Traffic Calming Improvements, Alfriston Stakeholder Engagement

PREPARED FOR:	Andrew Keer (ESCC)
COPY TO:	Karl Taylor (ESCC) & Alfriston Parish Council (APC)
PREPARED BY:	Andy Mileham (ESH)
DATE:	24 th October 2022
PROJECT NUMBER:	678223-SCH:149
TECHNICAL NOTE:	05
APPROVED BY:	Andy Mileham (ESH)

Project: Alfriston Village 20mph Study
Drawing title: Preliminary design of village-wide 20-mph speed limit Market Square - High Street road markings

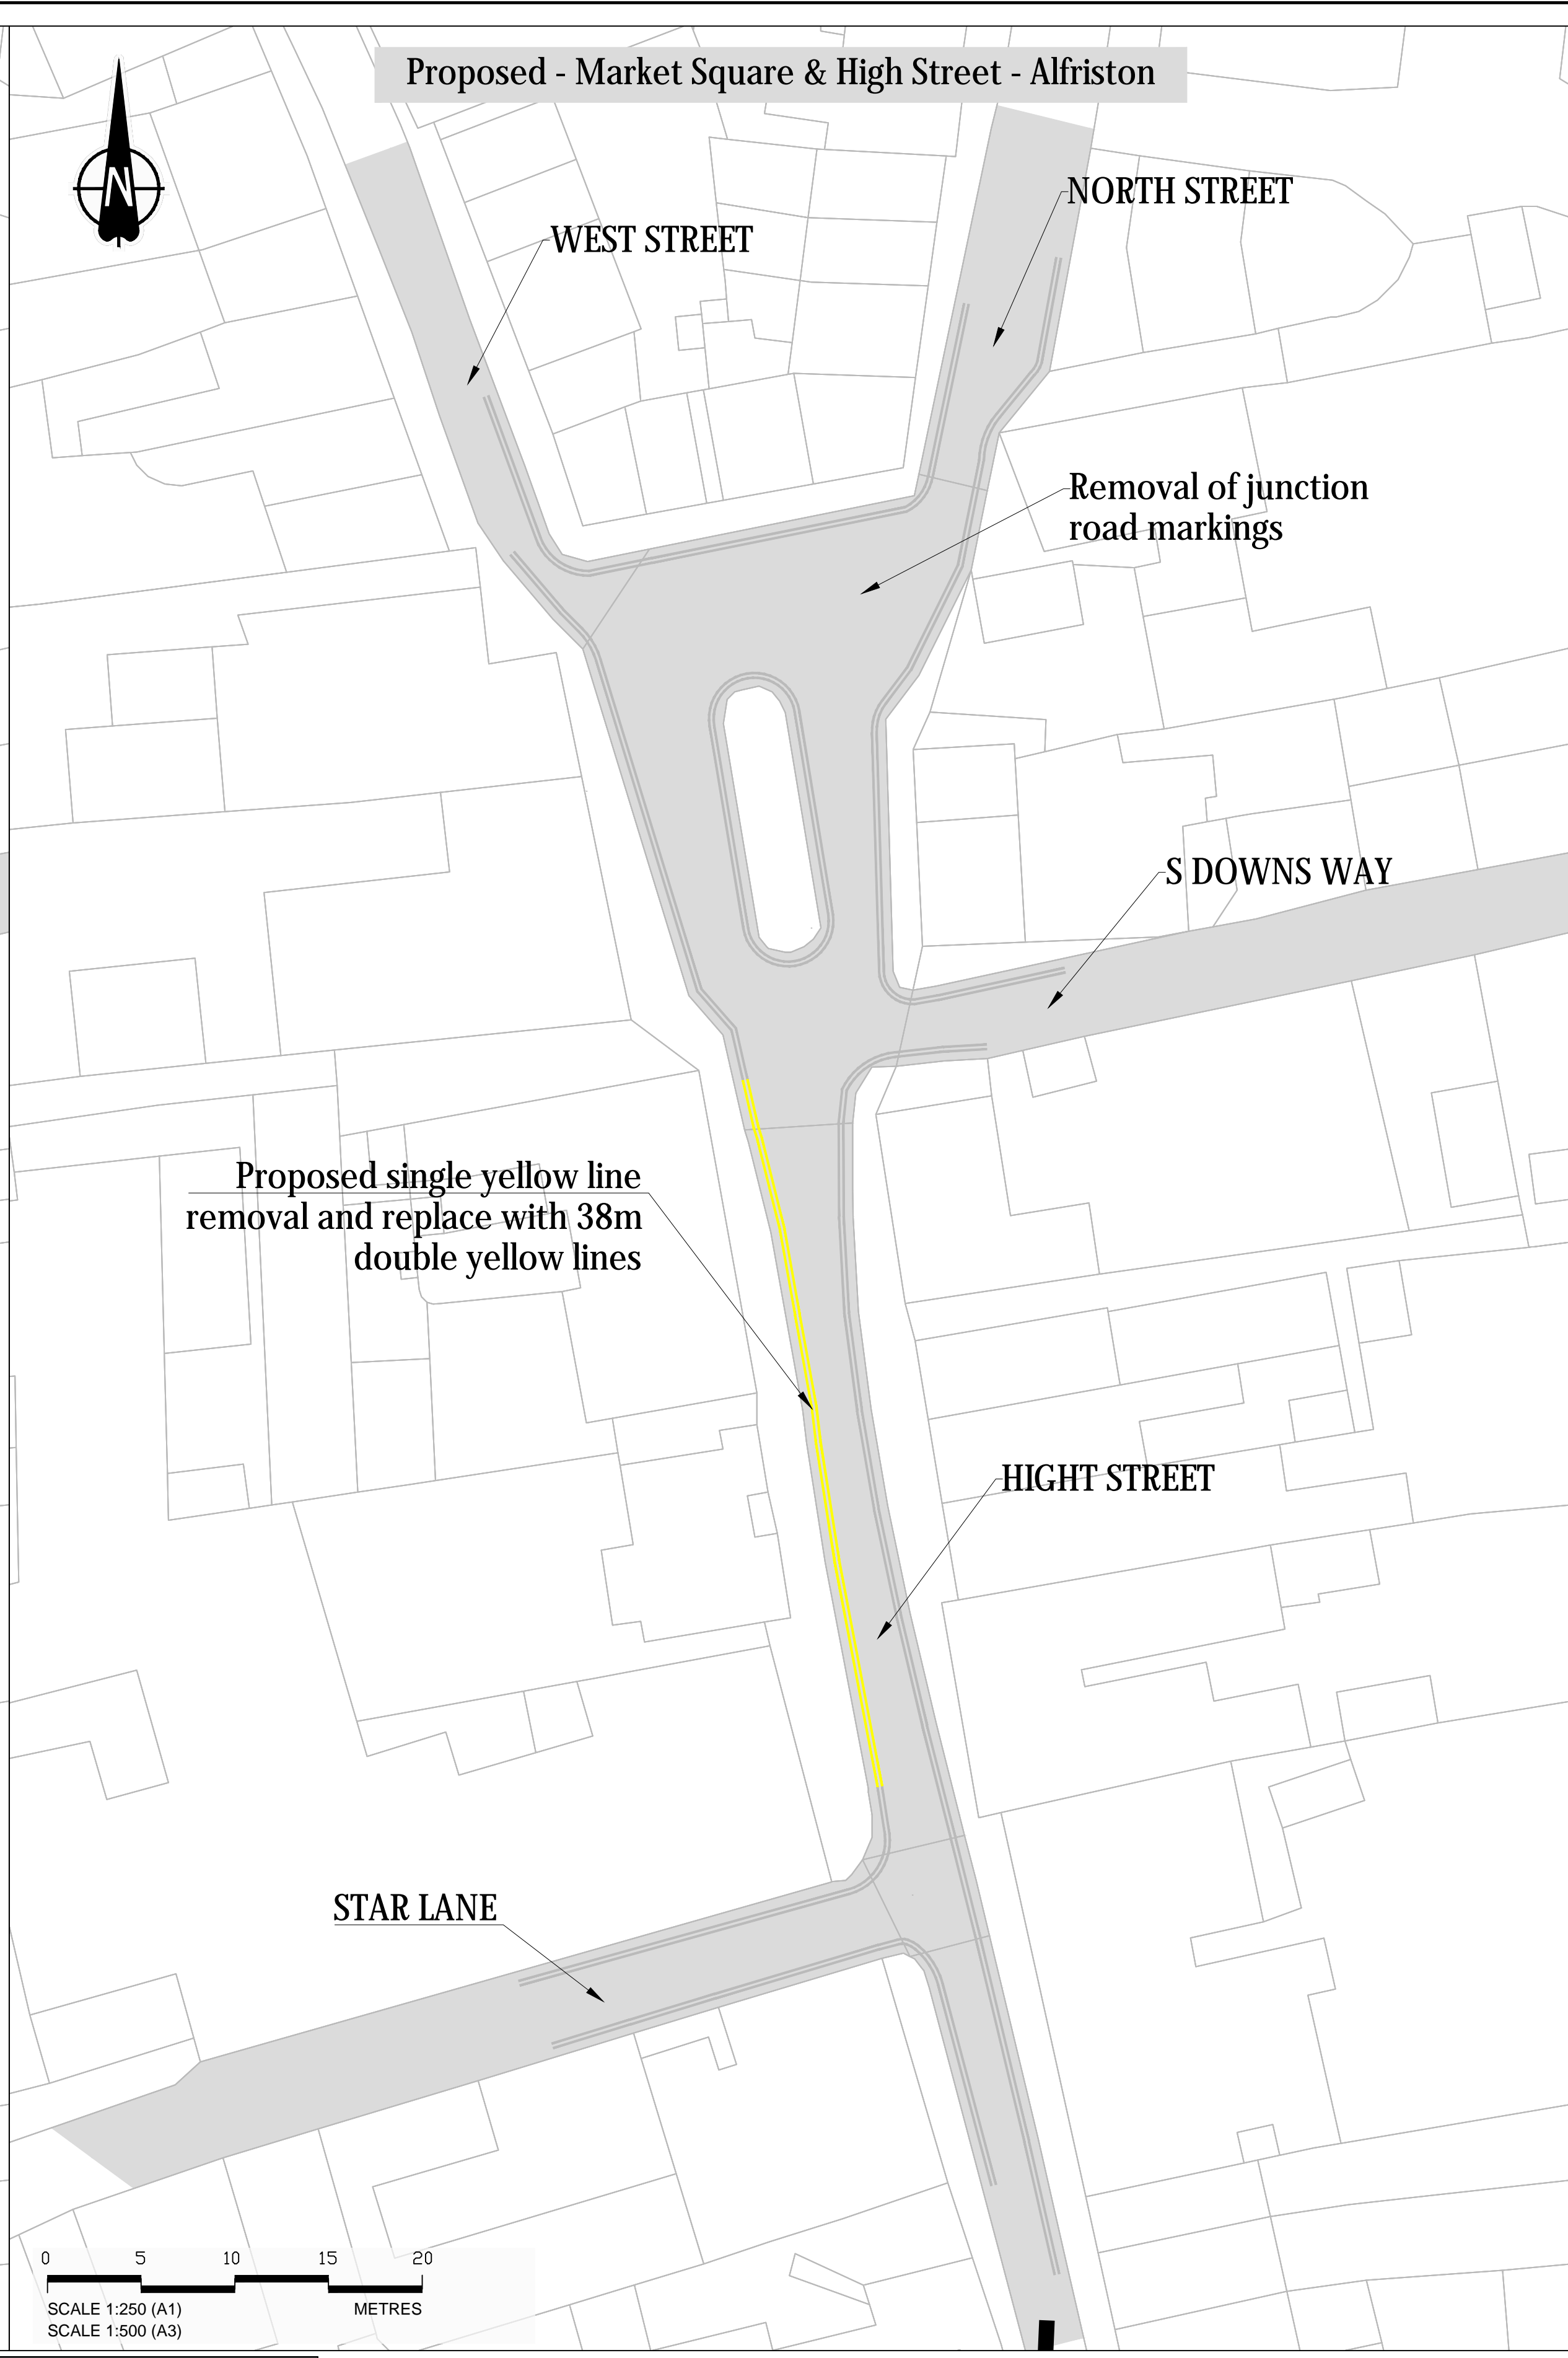
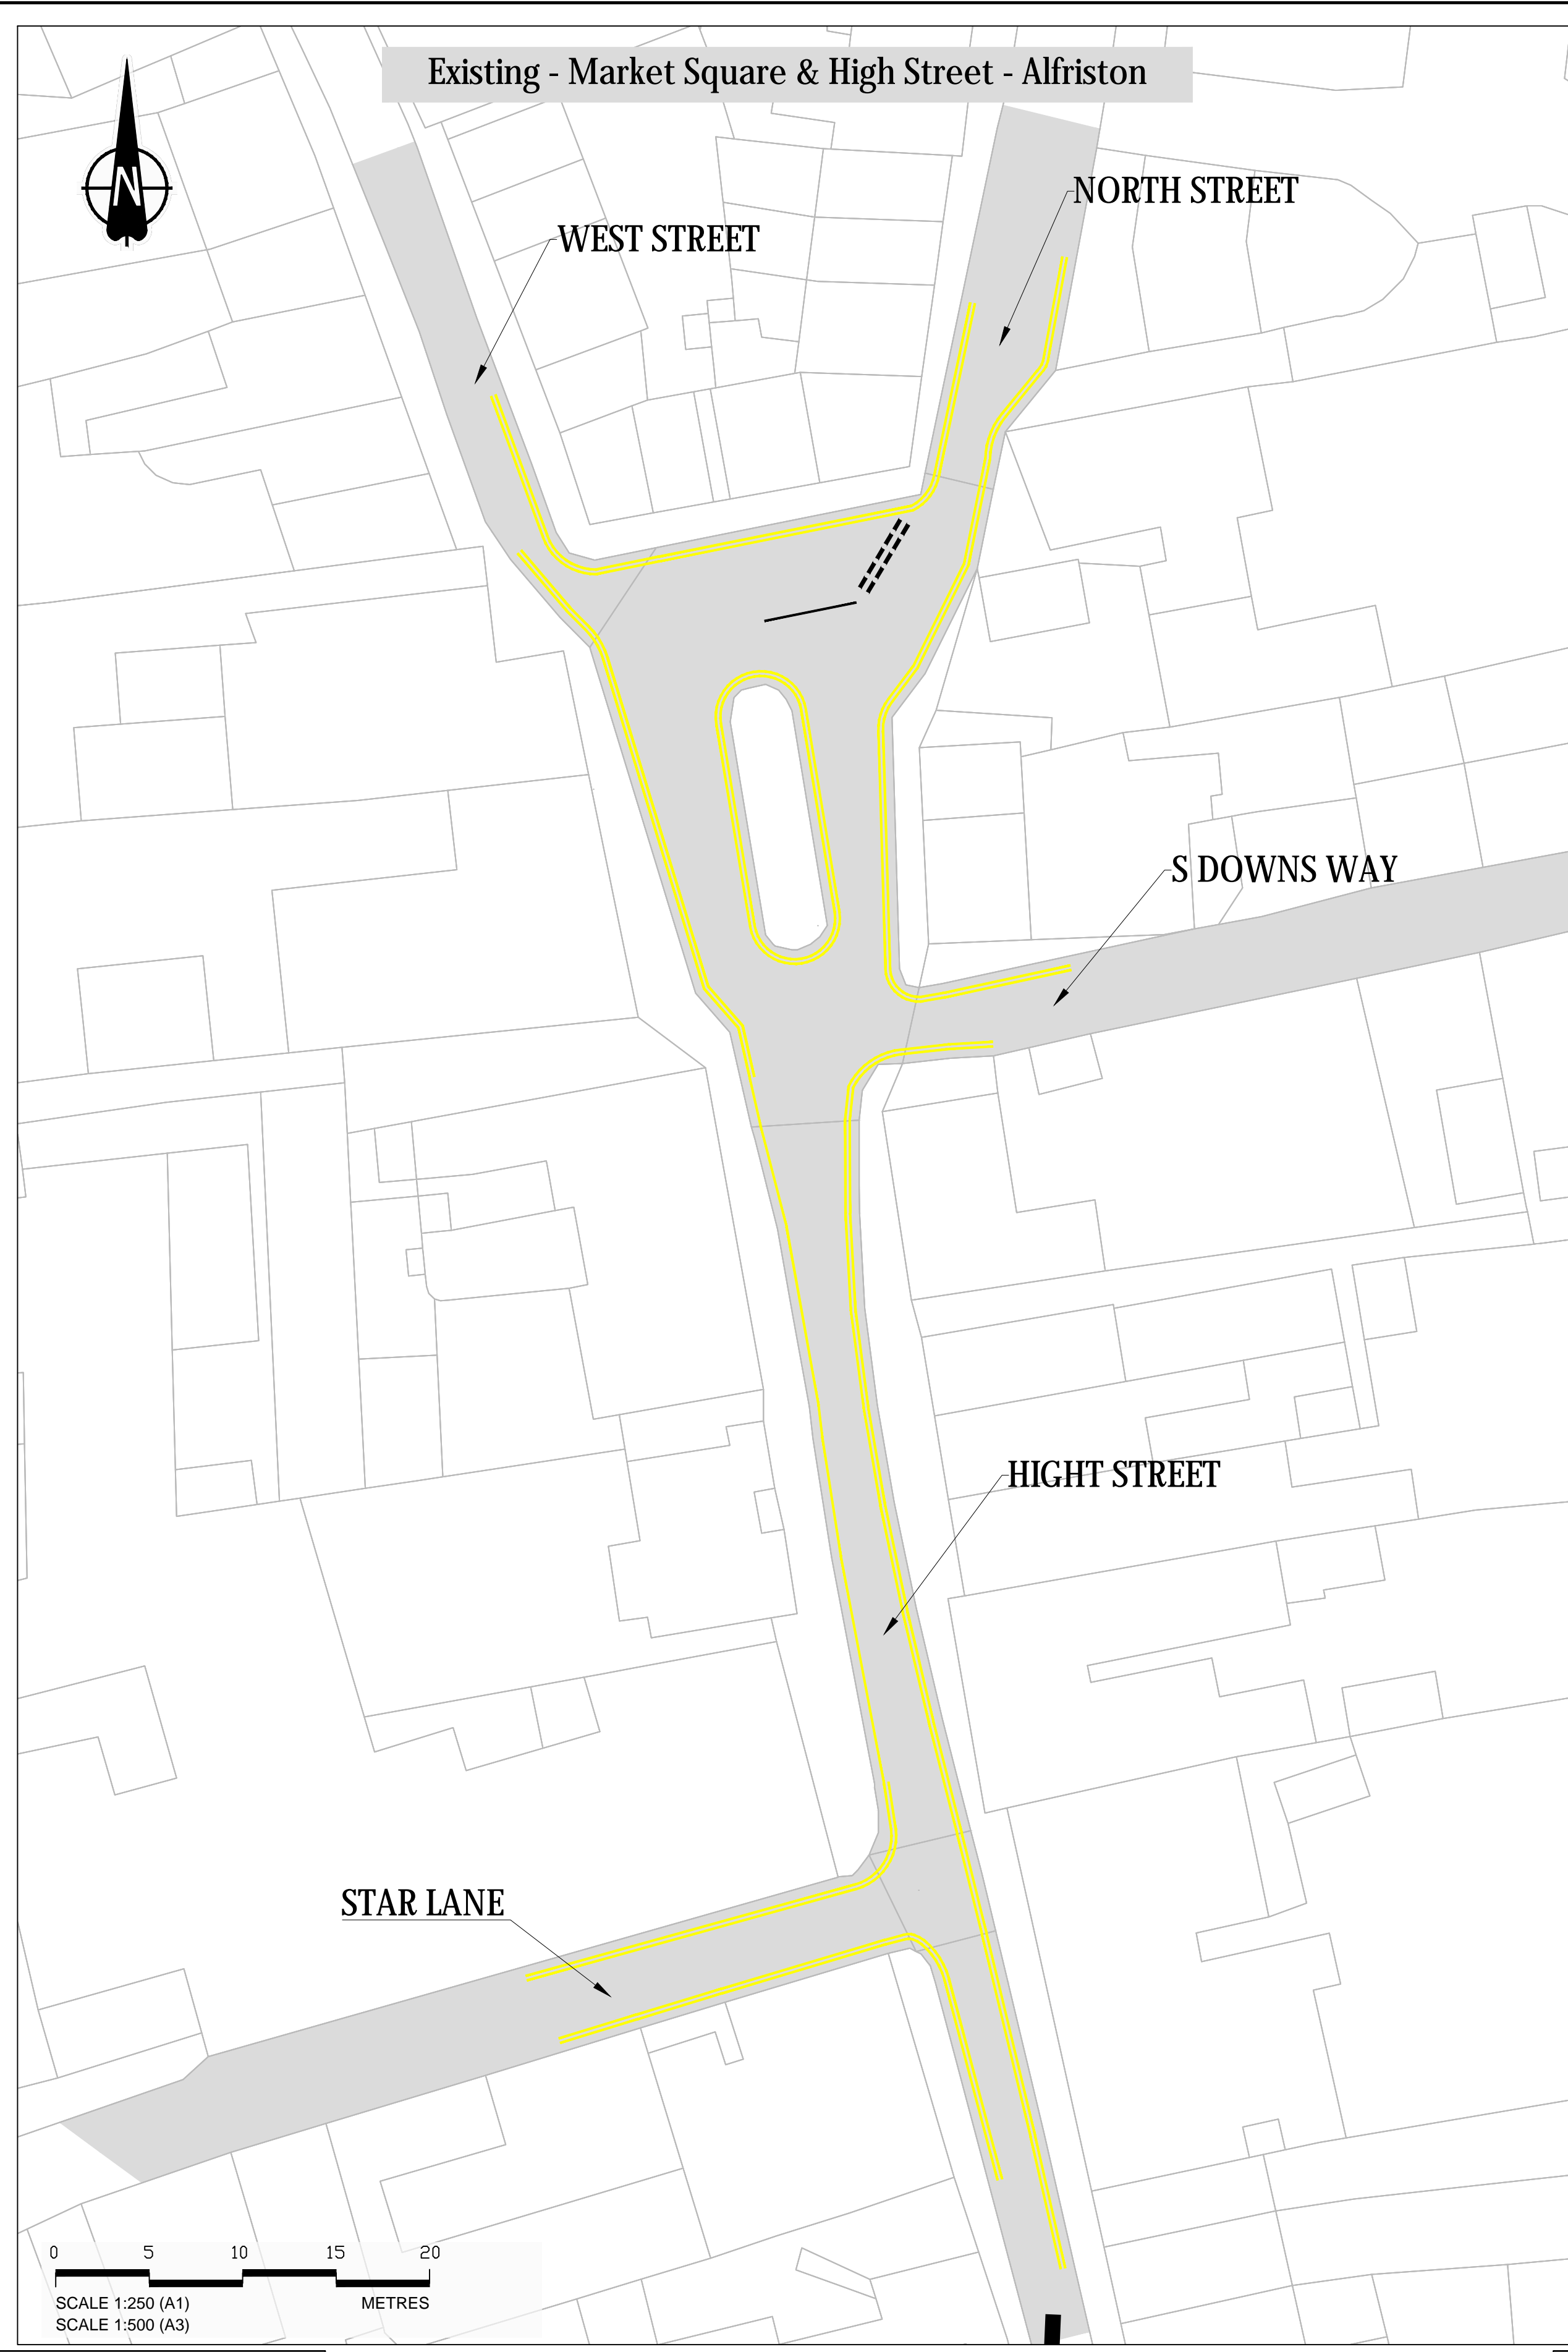
The decluttering of road markings and yellow lining around the central market square is appreciated, but it should be noted that the upgraded double yellow lining on High Street should be in colour No 310 (Primrose) as specified by Traffic Manual chapter 5 for use in environmentally sensitive areas”.

In addition to the above comment, ESH received the following response from the Road Safety and Traffic Management Team at Surrey and Sussex Police that specified *“we do have concerns about the removal of the give way lines in Market Square. They clearly serve a purpose, particularly with the poor visibility to the left at this junction. They are a road safety feature and removal of such a feature is a serious step to take, with potential repercussions if this leads to an increase in collisions. However, the introduction of a 20mph speed limit may go some way to offset the removal of this road safety feature”.*

The Cuckmere Community Bus Company stated that *“by extending the double yellow lines along High Street will make a big difference. The cones unofficially placed along that section have deterred most from parking but making it formal is good. As far as bus stops are concerned, there is currently a bus stop marked on the road beside the oak tree at the Market Cross. In fact, services pull up parallel to the centre island outside and opposite the Stores to leave the main carriageway on the other side of the island clear for traffic to flow.*

ESH note the endorsement from the SDNPA on the removal of the road markings and yellow lining around the central market square.

ESH Response – As highlighted within the previous response the proposed design options have achieved approval from a GG119 highway safety point. However, the point raised regarding the lack of visibility is indeed valid and will again form part of our discussions during the public consultation stage of the project. However, it is hoped that the introduction of a 20mph speed limit within the village of Alfriston will improve driver awareness through a 'sense of place' by making the area more welcoming to both pedestrians and cyclists.

ESH Response – ESH note the endorsement from the Cuckmere Community Bus Company regarding the extension of double yellow lines along the High Street.
